**ACI COMMITTEE 437
STRENGTH EVALUATION OF EXISTING CONCRETE STRUCTURES**

**Main Committee Meeting
2011 ACI Fall Convention – Cincinnati, Ohio
17 October 2011, 10:30 am - 12:30 pm
Duke Energy Center – Room 202**

MEETING MINUTES

7.2 **Task Group: Code Requirements and Commentary for Load Testing of Existing Concrete Structures**

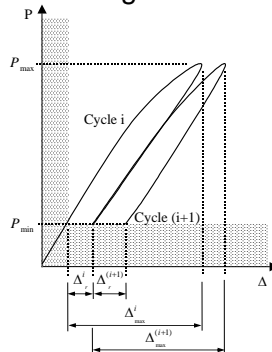
Comment No. 12

Member: Galati

Page 23, Line 6-8

The figure shall be replaced with the following:

<u>Discussion:</u>
Larosche: Negative withdrawn by Galati
<u>Action:</u>
No vote required
Vote Count: Affirmative:-- Negative:-- Abstain:--
No vote
